# URBAN DESIGN COMMISSION APPLICATION

Address (list all addresses on the project site): 4205 Portage Road

Title: Vive

RE: 4205 Portage Road – Landscaping Mulch

**L1**  
 OVERALL LANDSCAPE

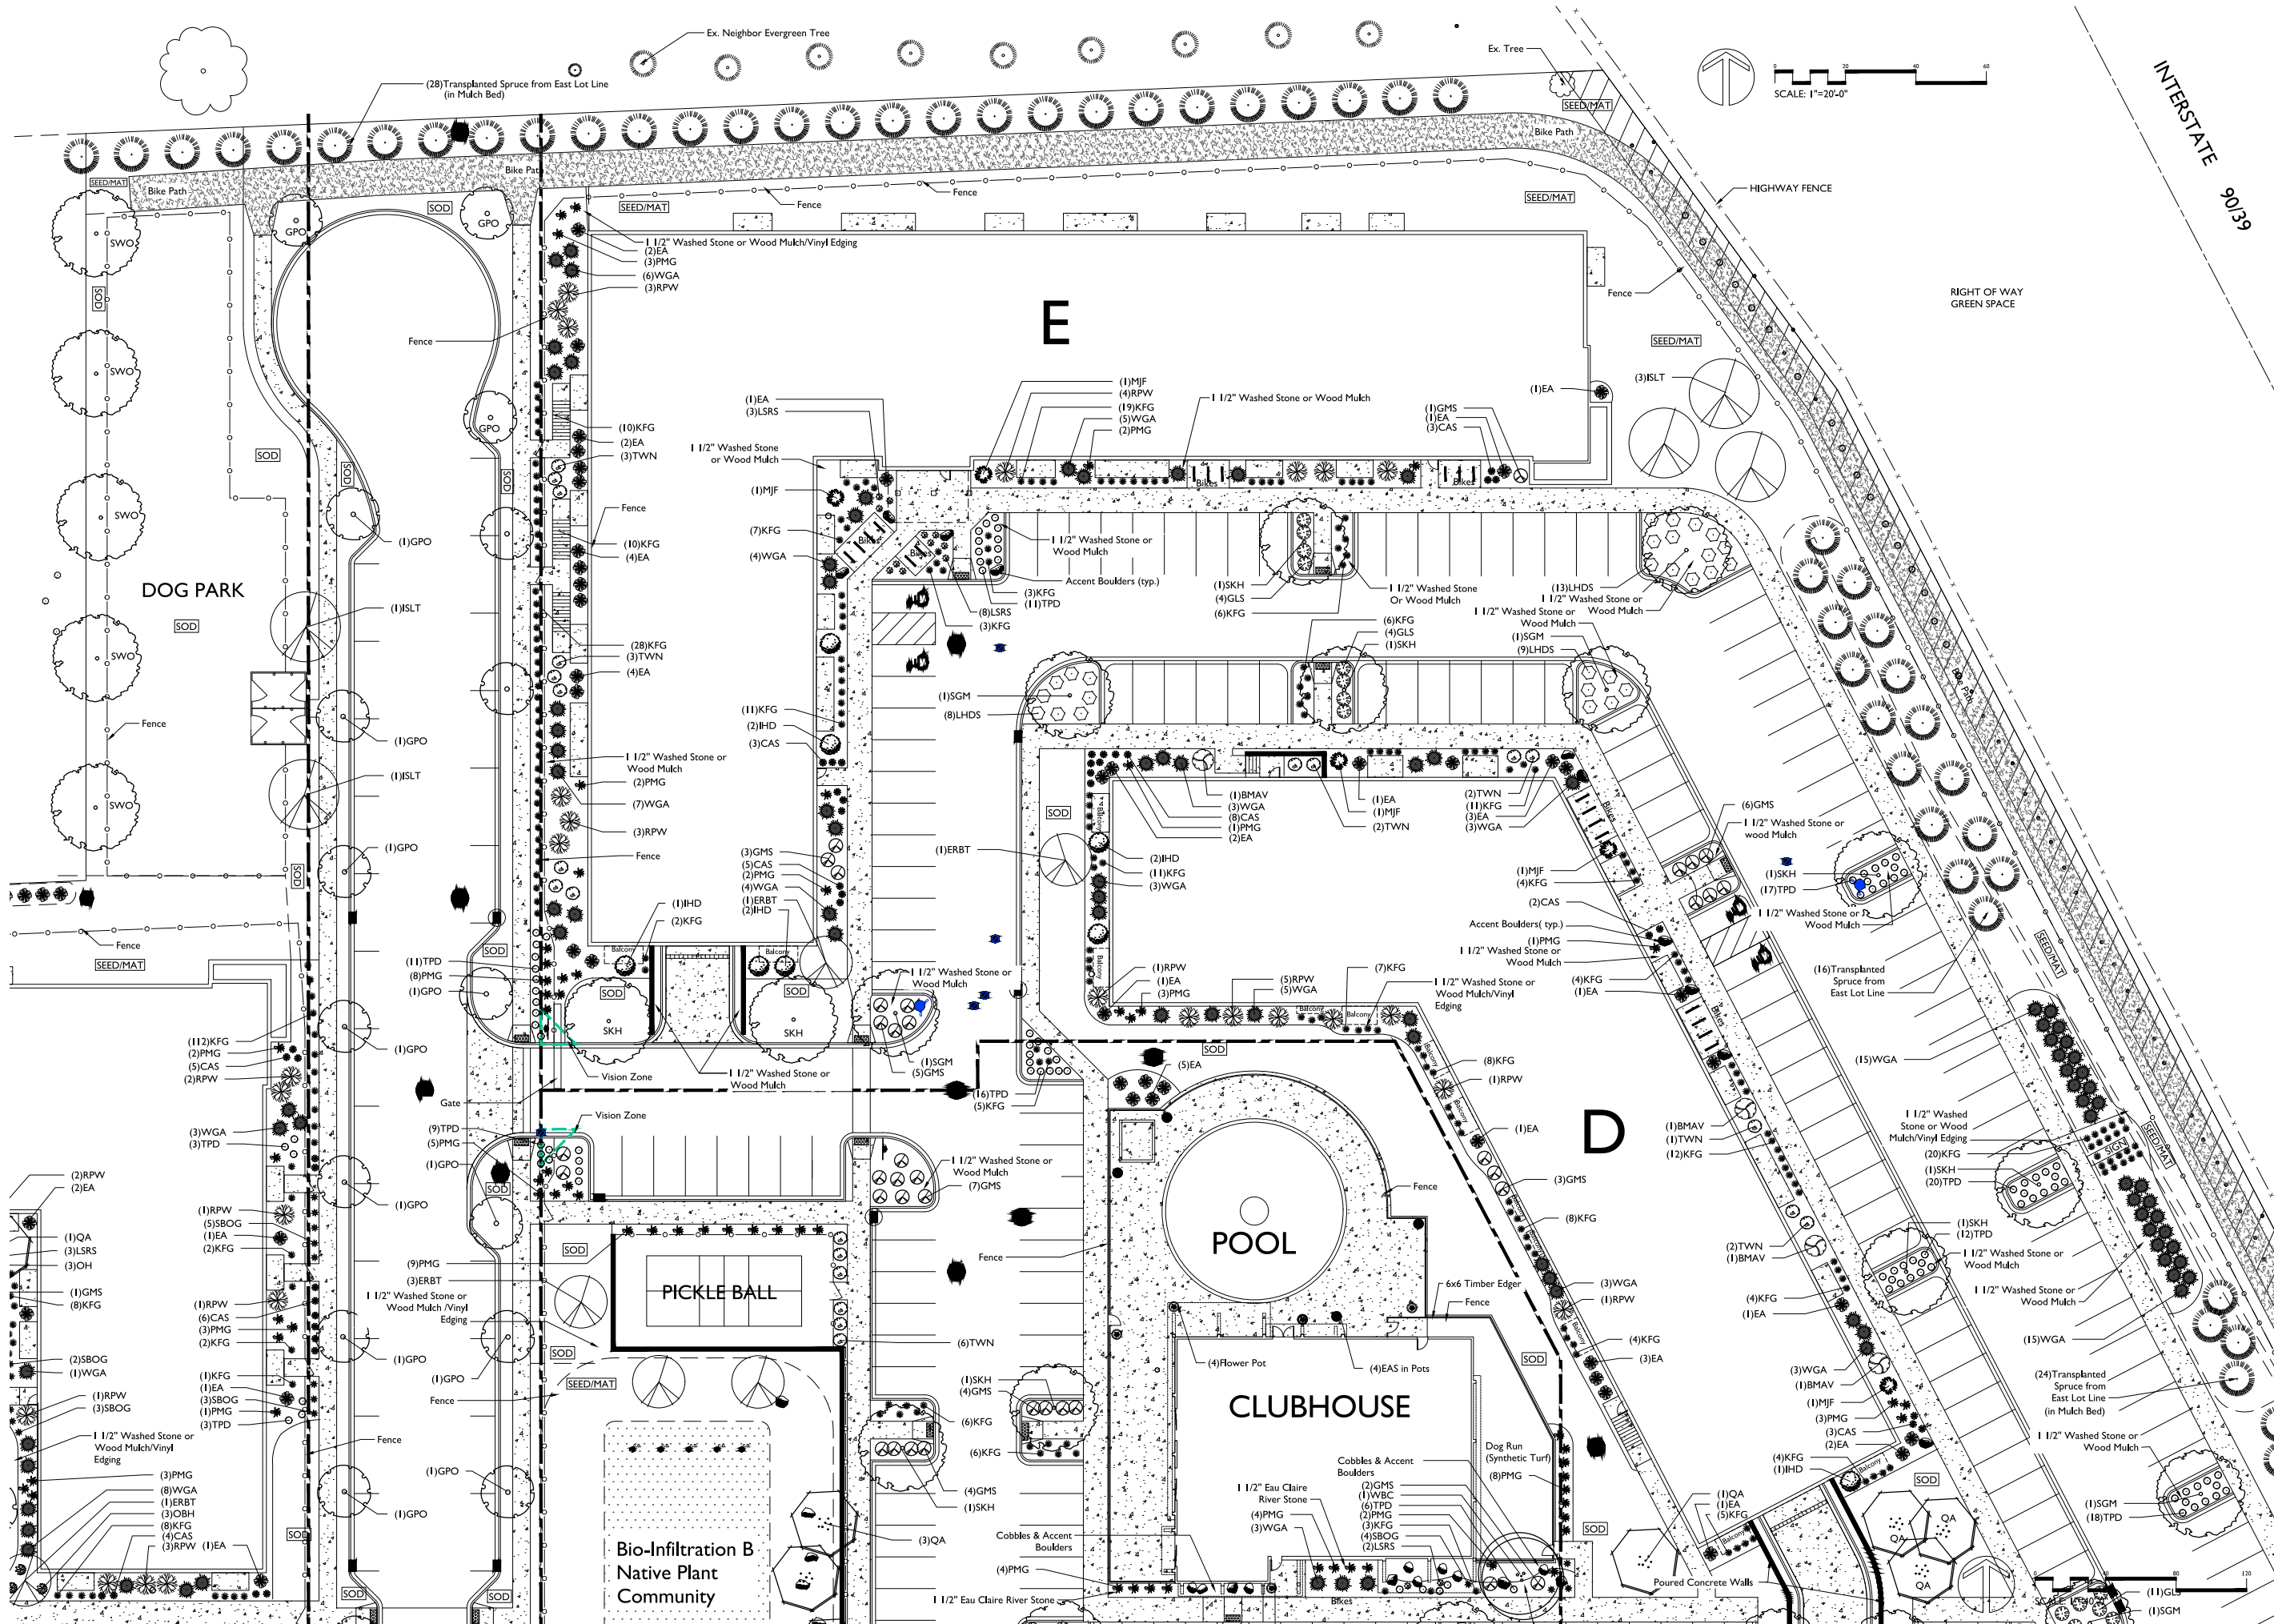
I am writing to request an alteration to the landscaping plan for property located at 4205 Portage Road. The approved plan suggested the use of wood mulch for the landscaping beds; however, we would like to install stone landscaping mulch as allowed by Madison General Ordinances Section 28.142(3)(c).

Stone mulch helps prevent erosion control during rainfall while wood mulch washes away as it does at some of our properties. Stone mulch is also less flammable than wood mulch, reducing the risk of fire hazard to our property and neighboring properties. Here is an image of a wood mulch plant bed at one of our properties after rainfall.
